ADDENDUM NO. 3

HVAC Upgrades to Second and Third Floors at Gretna City Hall for the City of Gretna, LA 740 Second Street, Gretna, LA	Burgdahl & Graves - A.I.A. Architects 2550 Belle Chasse Hwy., Suite 130 Gretna, LA 70053 504-366-4433 Fax 504-366-0102
--	---

SUBJECT: Gretna City Hall
740 2nd Street, Gretna, LA
2nd Floor HVAC
GVA Project No. 4261

**MECHANICAL RENOVATION
THIRD FLOOR PLAN**
SCALE : 1/4" = 1'-0"

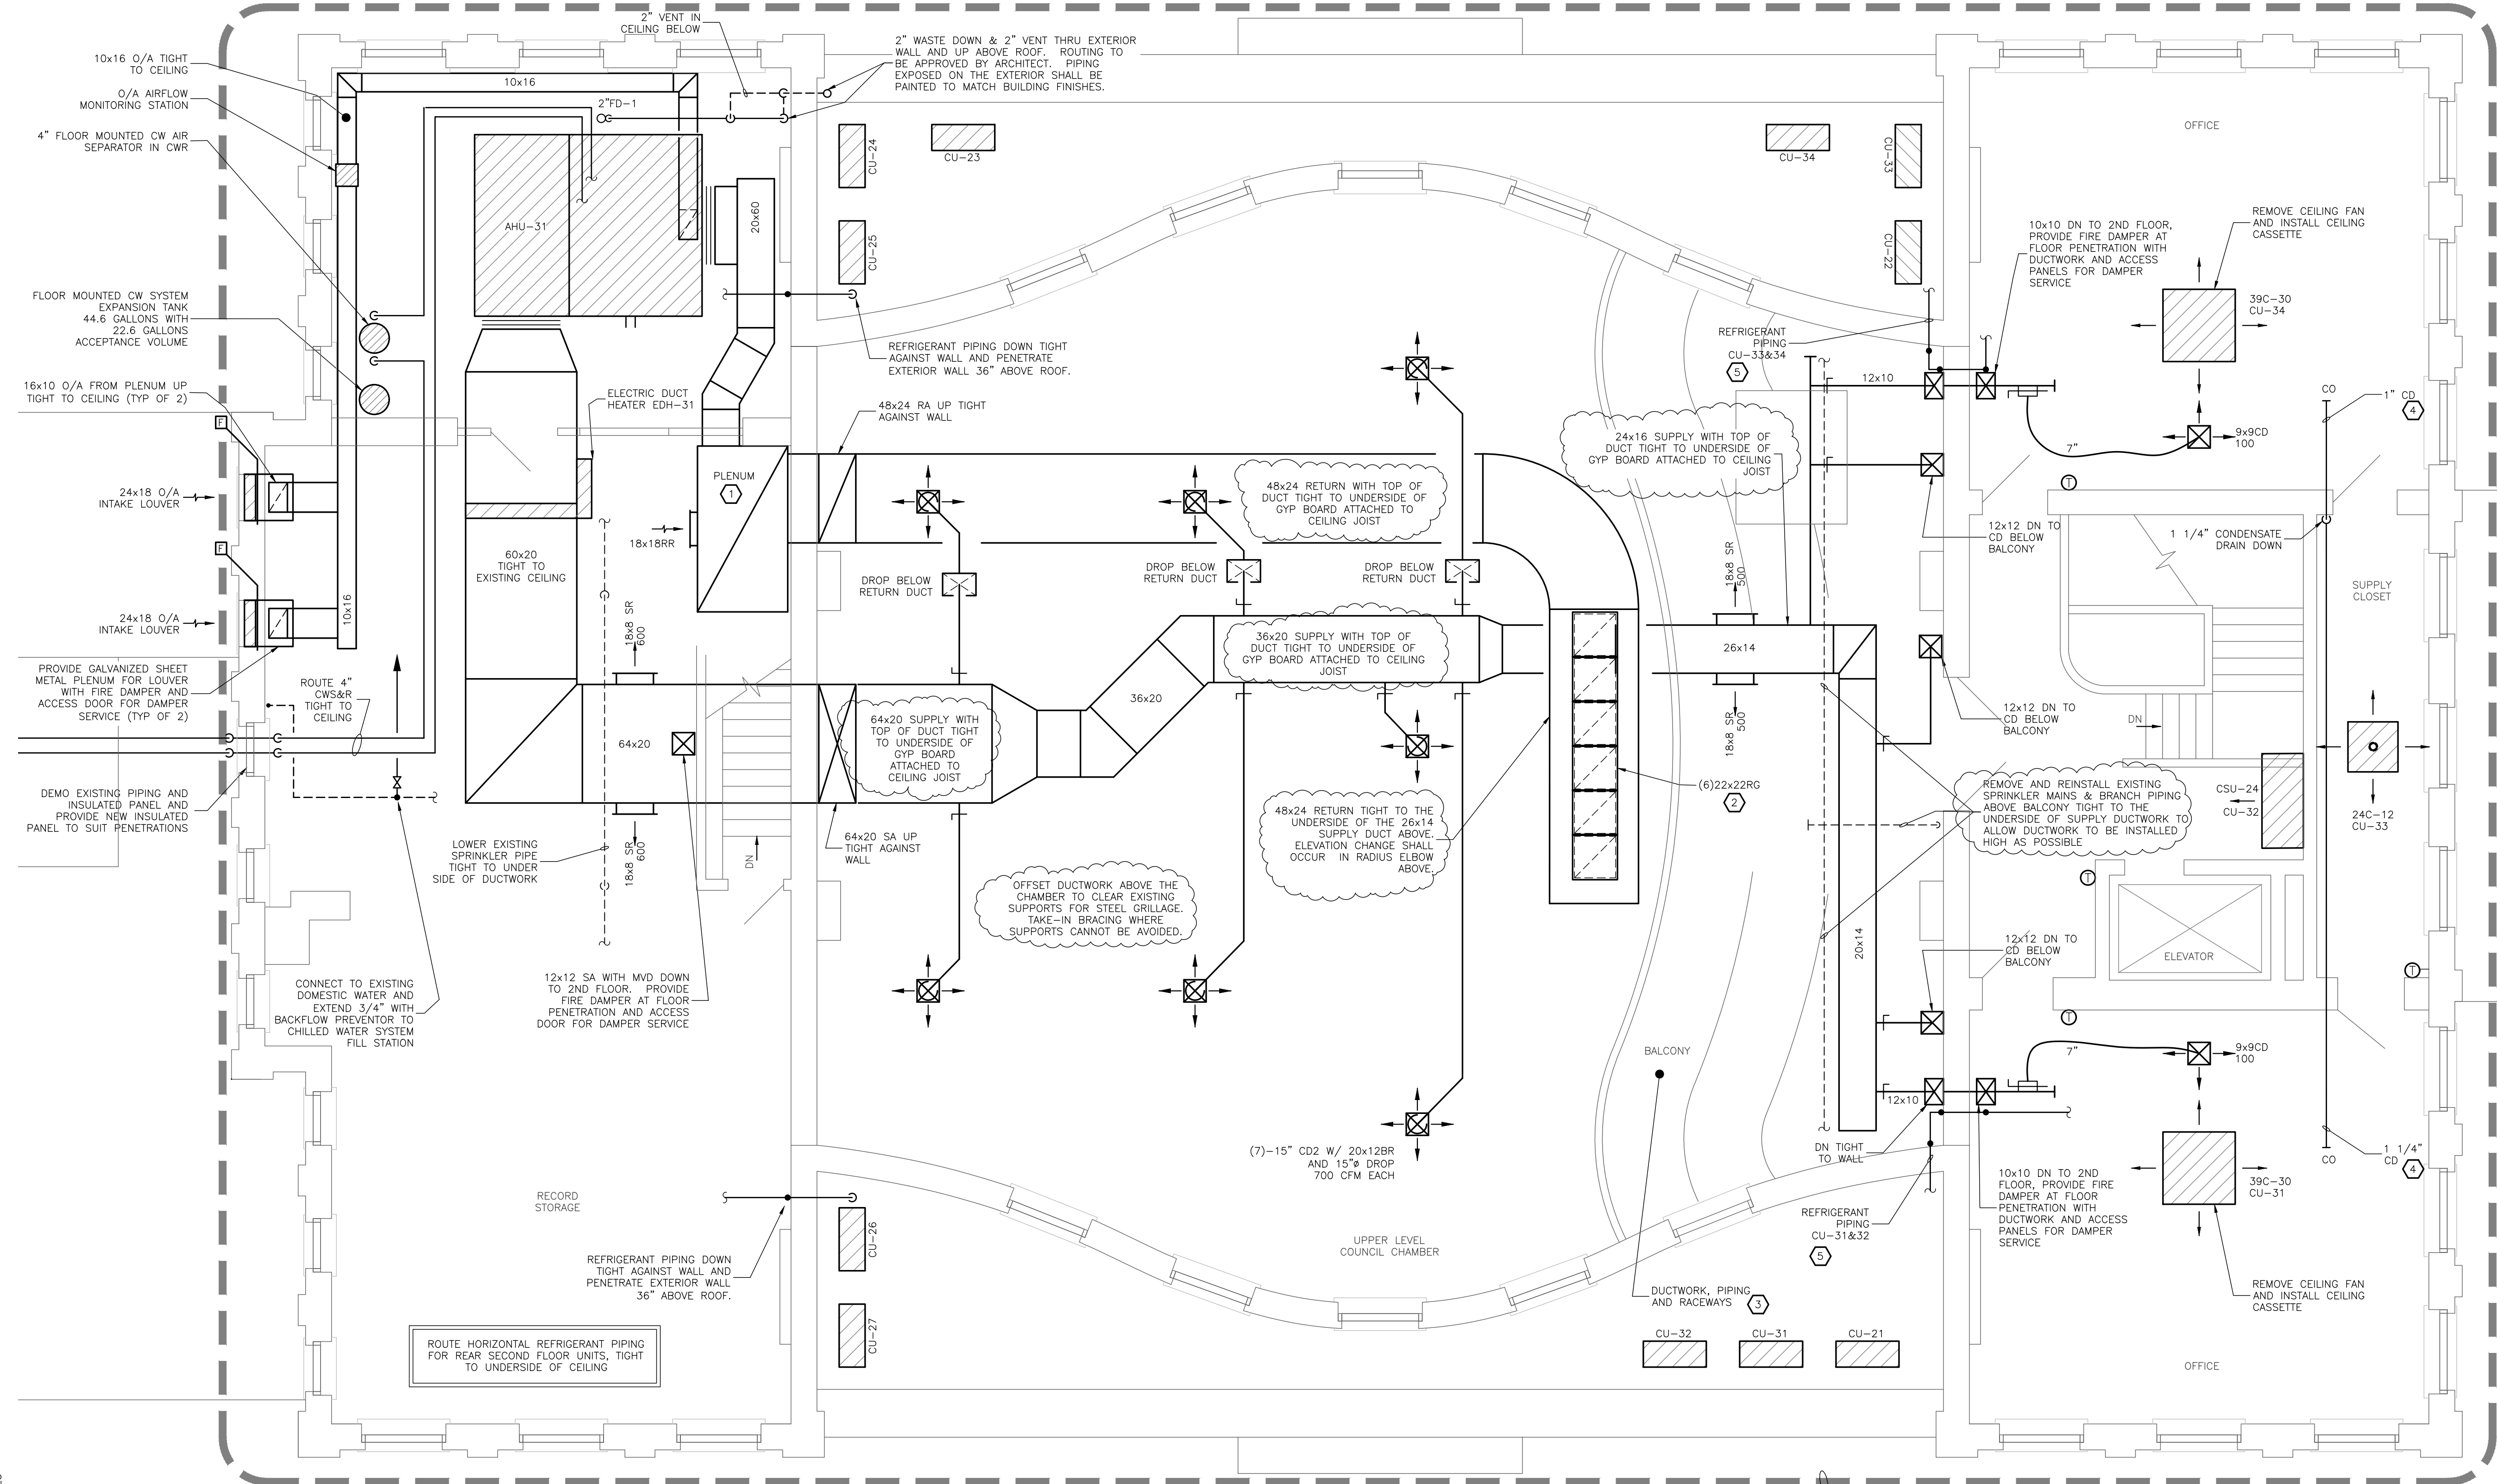
3. Drawing Sheet M4, Mechanical Renovation, Third Floor Plan: Replace Sheet M4 with revised sheet with duct-work tight to underside of the high ceiling in the upper Council Chamber area and above the 3rd floor balcony.

- 1 Replace Sheet M-4 with attached Sheet M-4 which has a revision date of 08-27-2024. Revisions are clouded. The change generally involves installing main supply and return ductwork high as possible over the Chambers and Balcony. Additional modifications to existing sprinkler piping are shown to allow clearance to install the ductwork as high as possible.
